**Fisheries & Oceans Canada – Round 2 Information Request  
Responses - Gahcho Kué Project Environmental Impact Review**

GAHCHO KUÉ PROJECT ENVIRONMENTAL IMPACT STATEMENT  
ROUND 2 INFORMATION REQUEST RESPONSES

Round 2 Information Request Number: DFO 2-3

Subject: Technical Memo dated June 18th 2012, "*Detailed Alternatives Analysis Report*"

**Figure DFO 2-3-1**

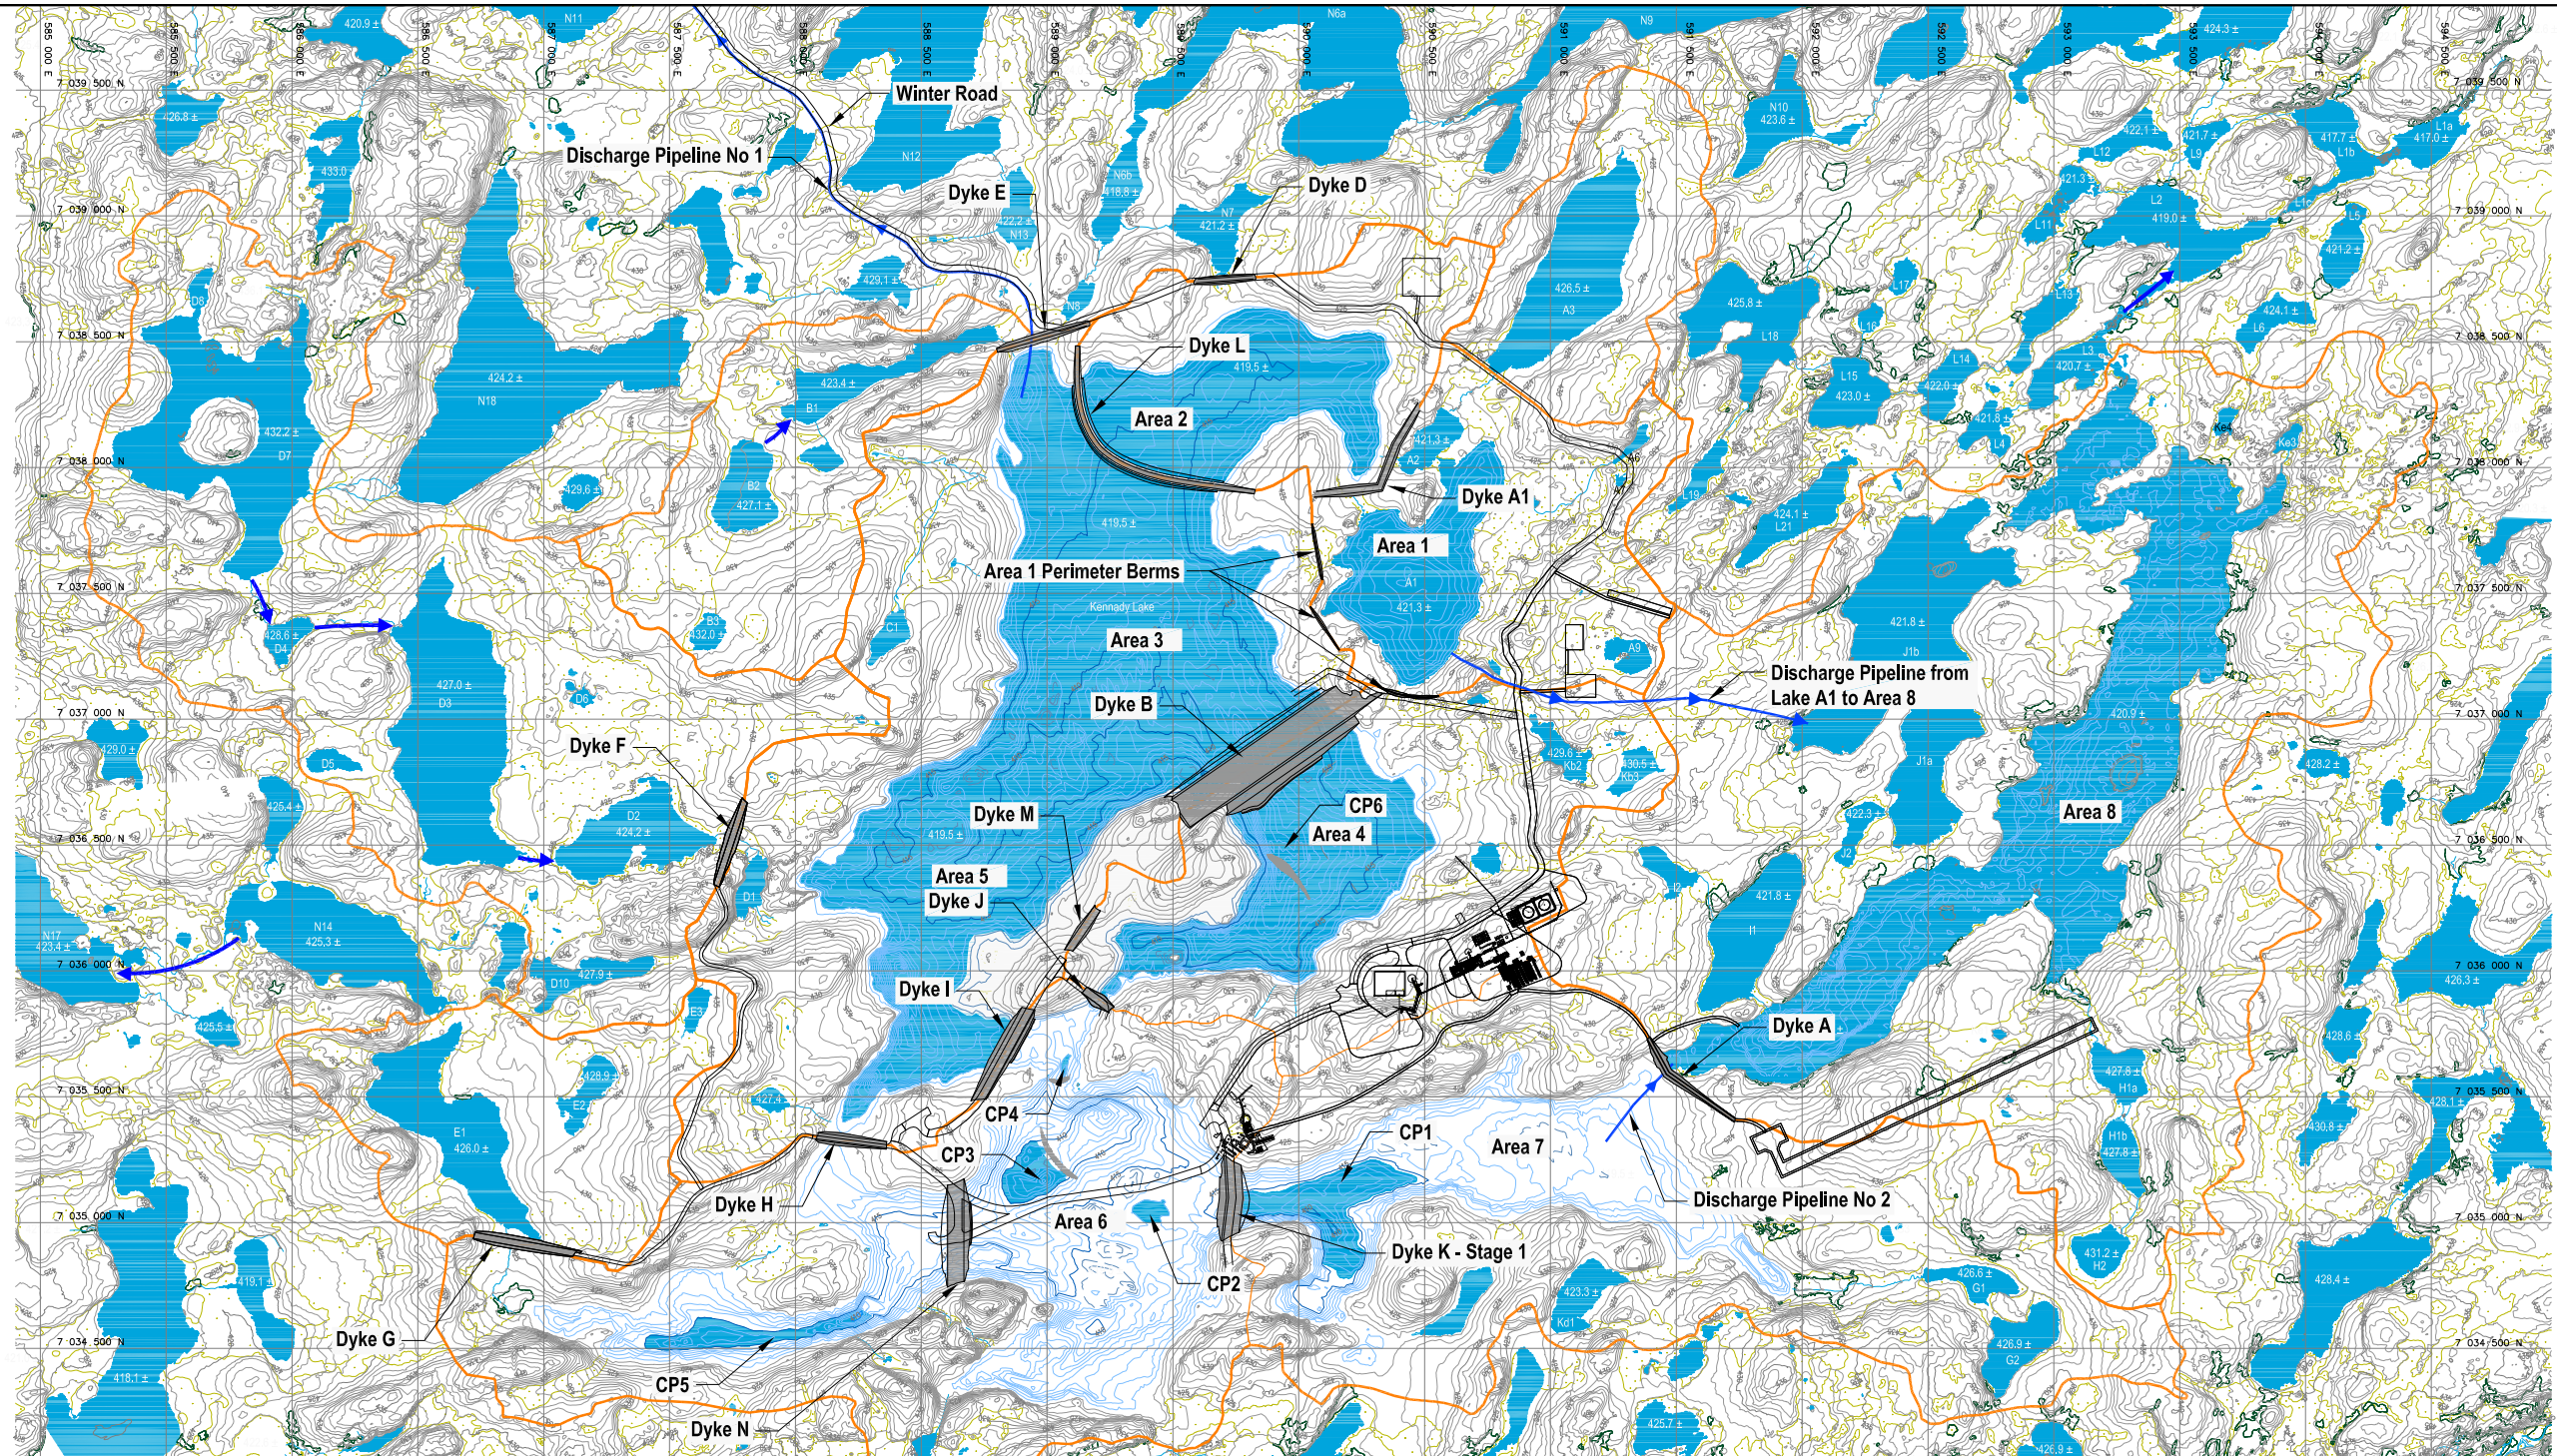
10. DeBeers has not provided sufficient evidence to prove that fish habitat in Areas 2, 3 and 5 will be destroyed by drawing down the water level by 3 metres. As there is no regulatory mechanism to allow the deposit of a deleterious substance, alternatives should be assessed by DeBeers accordingly.

Please provide additional information on the proposed alternatives that don't require the deposit of a deleterious substance into fish frequented waters (e.g. Option 6 or 3 in the Fine PK alternatives options).

- TSS levels in the drawdown of Areas 2, 3 and 5, will also be exacerbated as a result of additional mine activities, such as dyke construction (i.e., Dykes B, H, I, J, K, L, and M) (Figure DFO 2-3-1). In particular, the construction of dykes H, I, and L, will be wet installations (i.e., they will be constructed within the lake while water is still present), which causes far greater physical disturbance to the surrounding aquatic environment than dykes constructed in completely dewatered areas. The construction of dykes will further contribute to TSS in the dewatered portions of Kennady Lake over that which will potentially be mobilized through the initial withdrawal of water.
